RFP#16-18
FOUNDRY PLACE PARKING
GARAGE PERCENT FOR ART PROJECT
PORTSMOUTH, NH
November 28, 2017

Addendum#1

This Addendum forms part of the original document marked: RFP#16-18 Foundry Place Parking Garage Percent for Art Project.

COPYRIGHT © 2017. ALL RIGHTS RESERVED. NO PART OF THIS DOCUMENT MAY BE REPRODUCED IN ANY FORM OR BY ANY MEANS WITHOUT PERMISSION FROM WALKER PARKING CONSULTANTS / ENGINEERS, INC.

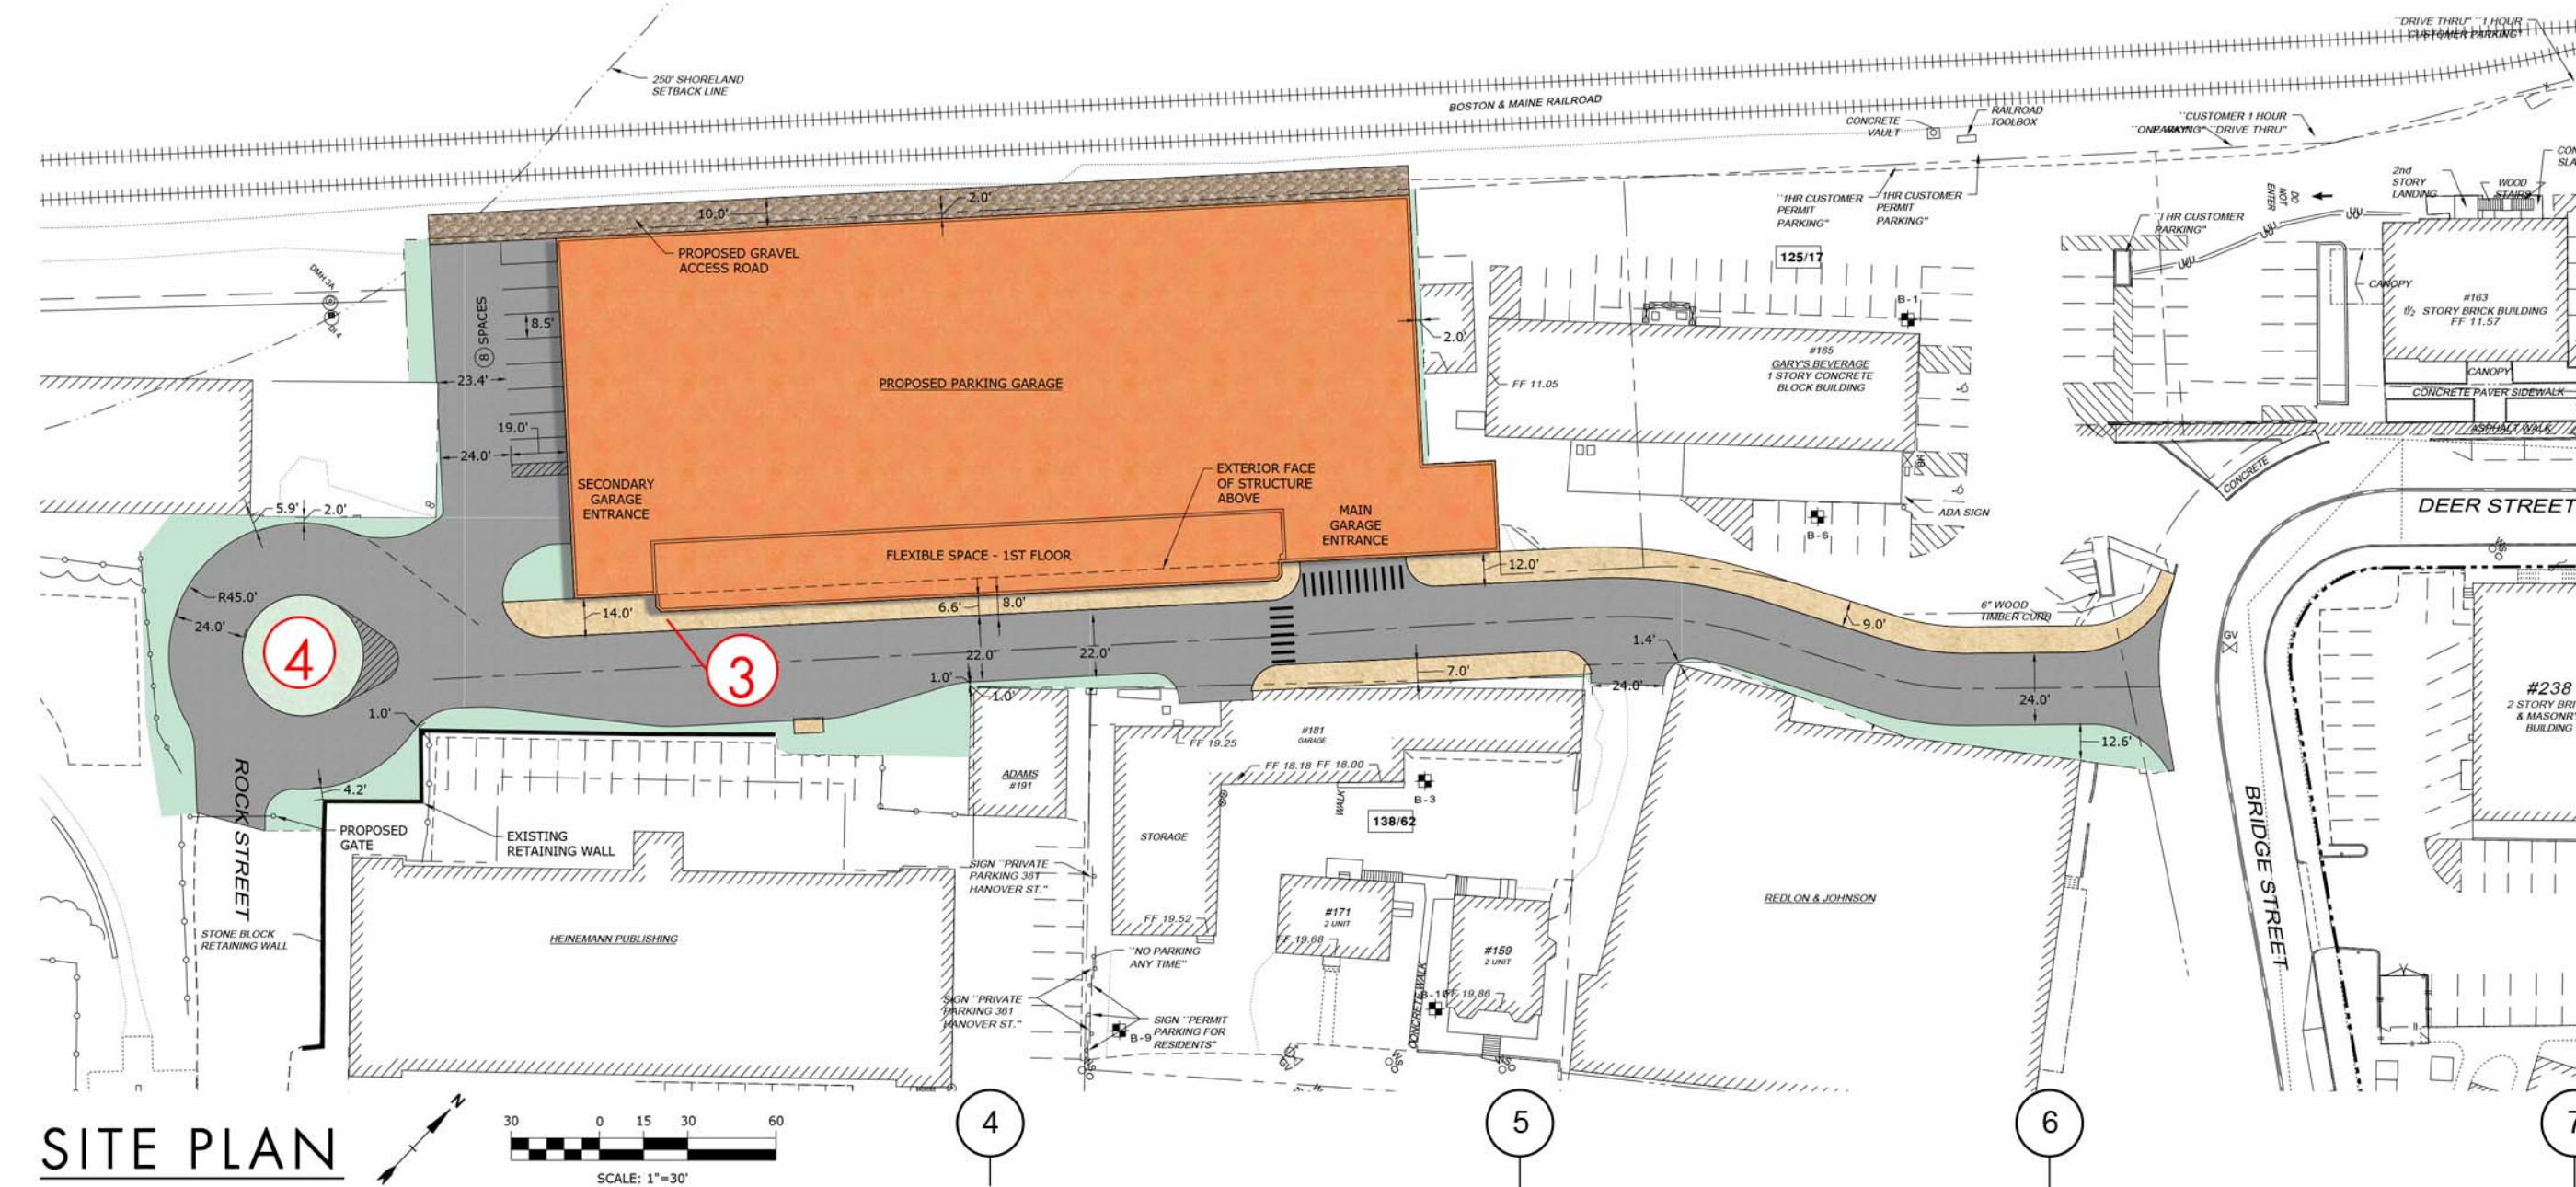
1. Please confirm this wall is CMU block on the stair side. What is the finish? Paint?
2. Could you verify the wall height and width for this wall on the stair side?

1. Please confirm this wall is pre-cast concrete on the stair side. What is the finish? Paint? Stain? Nothing?
2. Could you verify the wall height for this wall on the stair side?

1. Please confirm this wall is CMU block on the stair side. What is the finish? Paint?
2. Could you verify the wall height and width for this wall on the stair side?

1. Please confirm this wall is pre-cast concrete on the stair side. What is the finish? Paint? Stain? Nothing?
2. Could you verify the wall height for this wall on the stair side?

POTENTIAL ART LOCATIONS
FOUNDRY PLACE PARKING GARAGE
 PORTSMOUTH NH

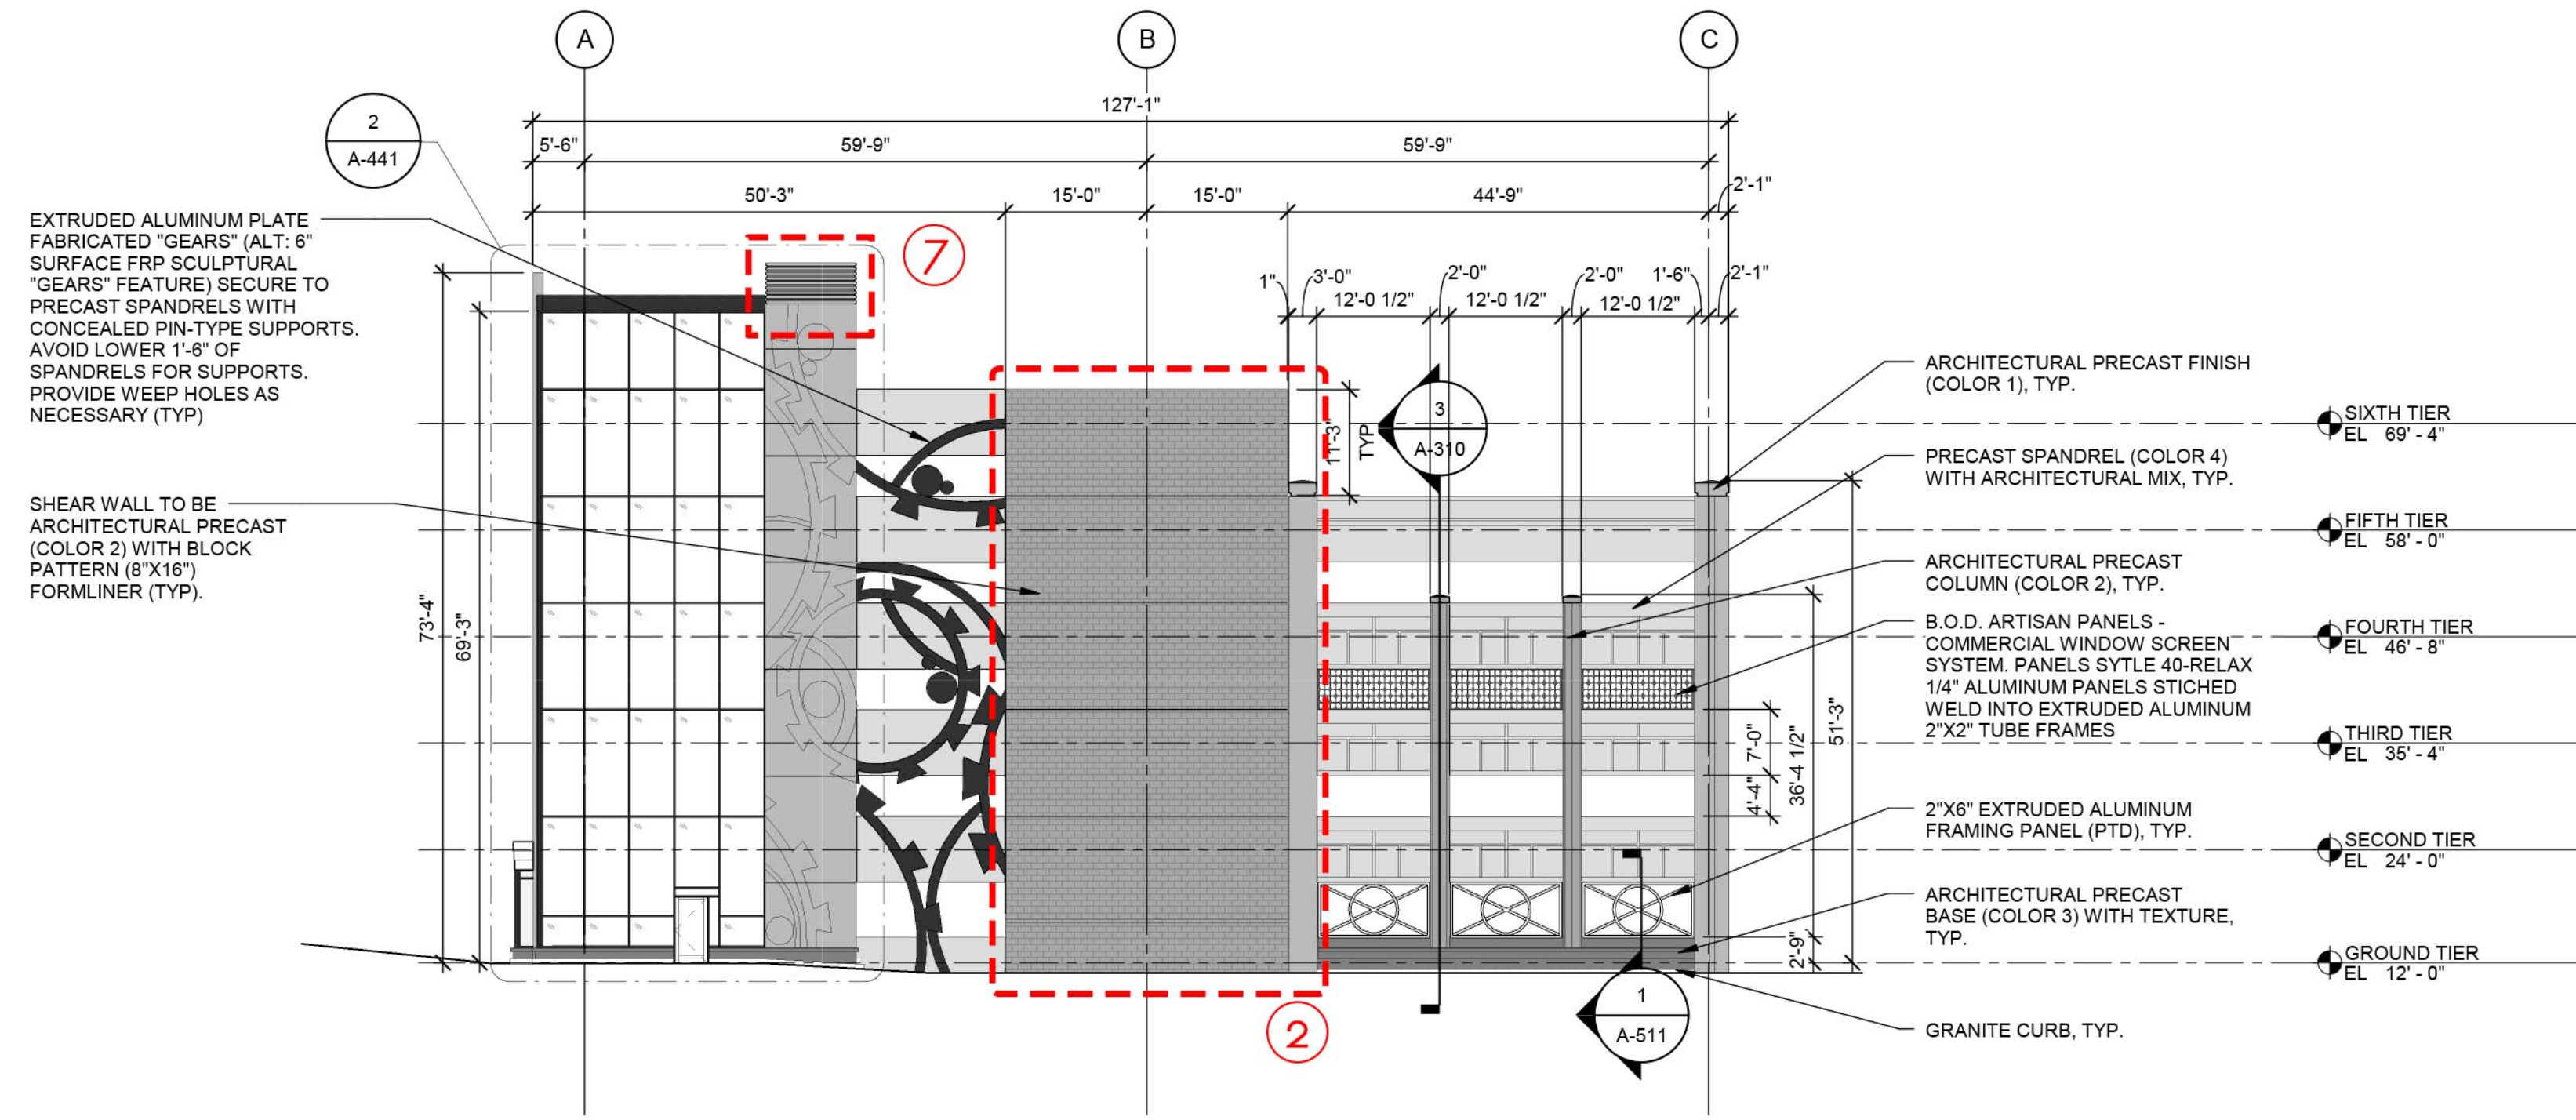
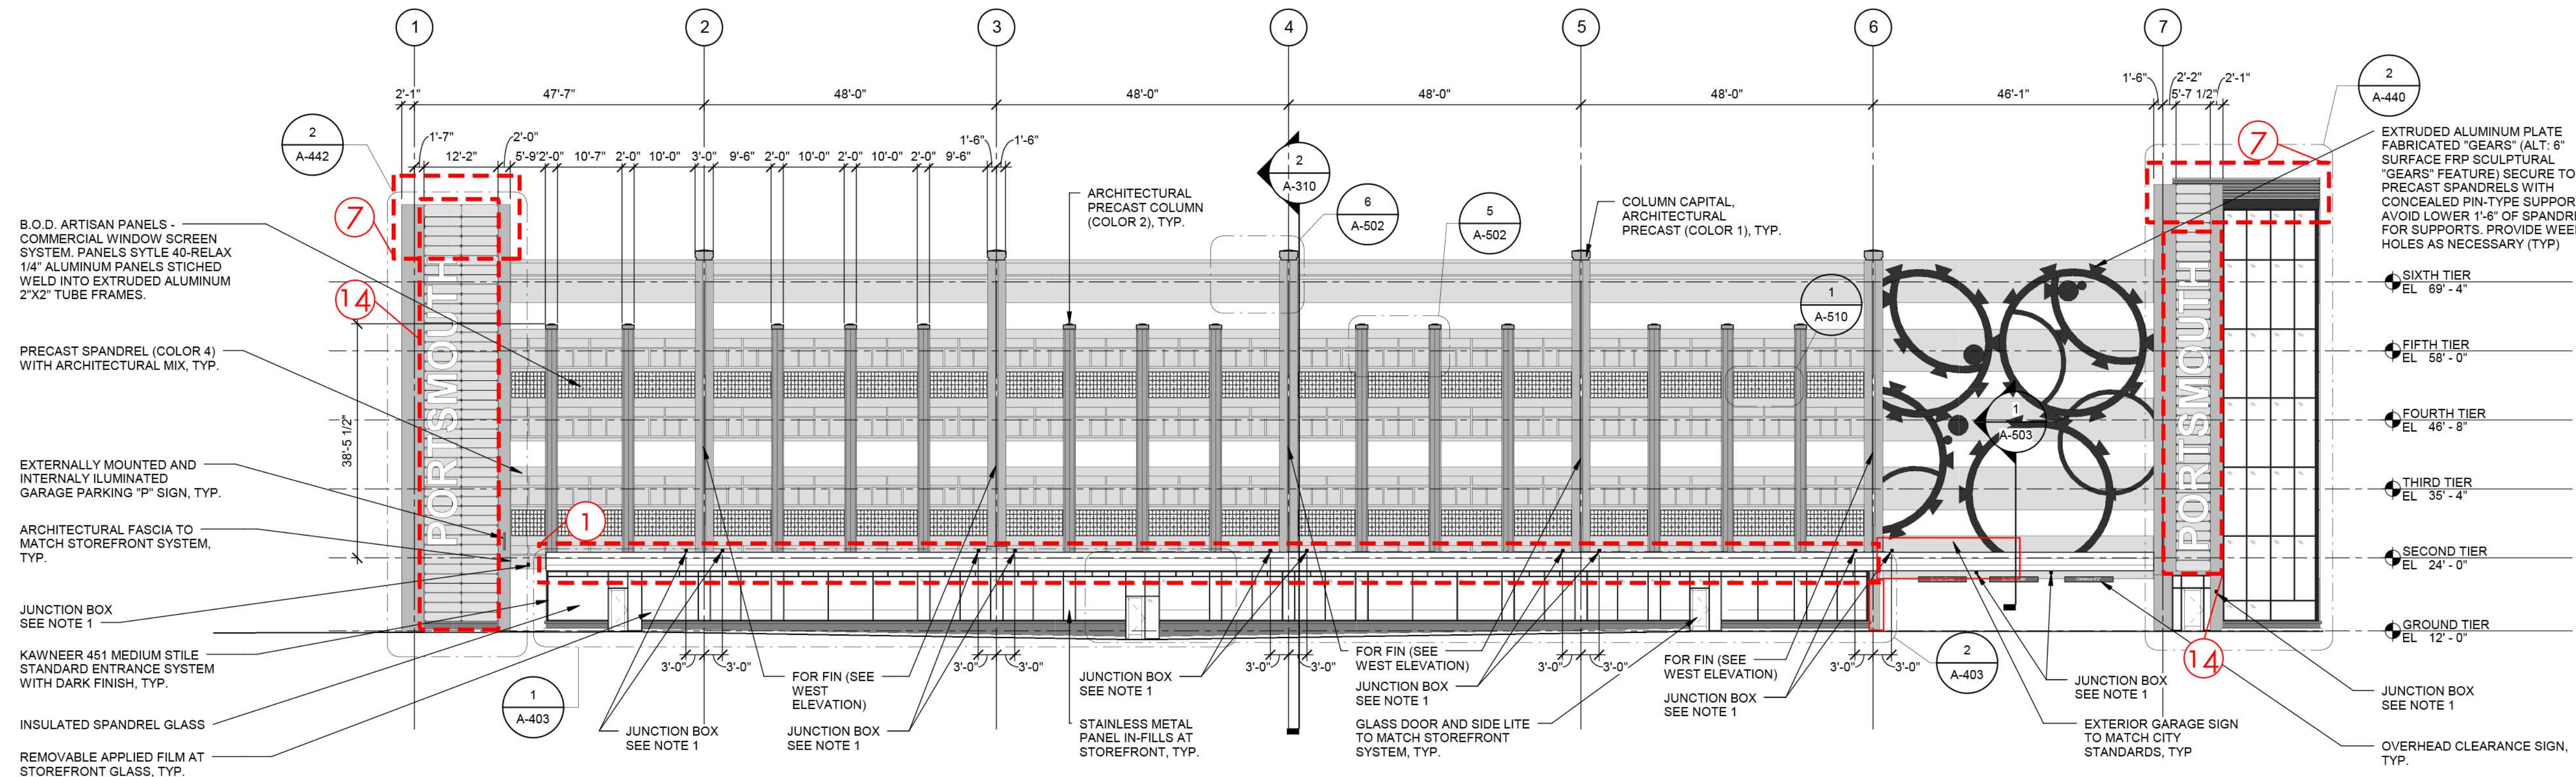
CONSIDERATIONS		ELECTRICITY EASILY AVAILABLE	STRUCTURAL CONSIDERATION	WIND LOAD CONSIDERATION	MOUNTING RESTRICTIONS	COMMENTS
LOCATIONS						
1. TOP OF FLEX SPACE ROOF						
2. SHEAR WALLS						
3. GROUND SURFACE						
4. ROUNDABOUT CENTER						OVERALL DIAMETER OF PROPOSED INSTALLATION MUST NOT INTERFERE W/ FIRETRUCK TURNING RADIUS.
5. ENTIRE ELEVATION						SHOULD NOT PROJECT MORE THAN 4" FROM BUILDING FACE.
6. STAIR TOWER (INTERIOR)						
7. TOWER TOPS						
8. FIN SURFACE						
9. ELEVATOR SURFACE (INT.)						MINIMAL IMPACT ALLOWED PER FIRE DEPT. & STATE ELEVATOR INSPECTOR GUIDELINES. GRAPHIC ONLY.
10. LIGHT WALL (INT.)						
11. BACKSIDE OF FLEX SPACE (INT.)						
12. UPPER WALL SURFACE OF TOWERS (INT.)						
13. STAIR B LANDING WALLS (INT.)						
14. PORTSMOUTH LETTER LOCATIONS						REQUIRES HIGH LEVEL OF COORDINATIONS FOR MOUNTING LARGE INSTALLATION.

CONSIDERATIONS				
LOCATIONS	ELECTRICITY EASILY AVAILABLE	STRUCTURAL CONSIDERATION	WIND LOAD CONSIDERATION	COMMENTS
1. TOP OF FLEX SPACE ROOF				
2. SHEAR WALLS				
3. GROUND SURFACE				
4. ROUNDABOUT CENTER				OVERALL DIAMETER OF PROPOSED INSTALLATION MUST NOT INTERFERE W/ FIRETRUCK TURNING RADIUS.
5. ENTIRE ELEVATION				SHOULD NOT PROJECT MORE THAN 4" FROM BUILDING FACE.
6. STAIR TOWER (INTERIOR)				
7. TOWER TOPS				
8. FIN SURFACE				
9. ELEVATOR SURFACE (INT.)				MINIMAL IMPACT ALLOWED PER FIRE DEPT. & STATE ELEVATOR INSPECTOR GUIDELINES. GRAPHIC ONLY.
10. LIGHT WALL (INT.)				
11. BACKSIDE OF FLEX SPACE (INT.)				
12. UPPER WALL SURFACE OF TOWERS (INT.)				
13. STAIR B LANDING WALLS (INT.)				
14. PORTSMOUTH LETTER LOCATIONS				REQUIRES HIGH LEVEL OF COORDINATIONS FOR MOUNTING LARGE INSTALLATION.
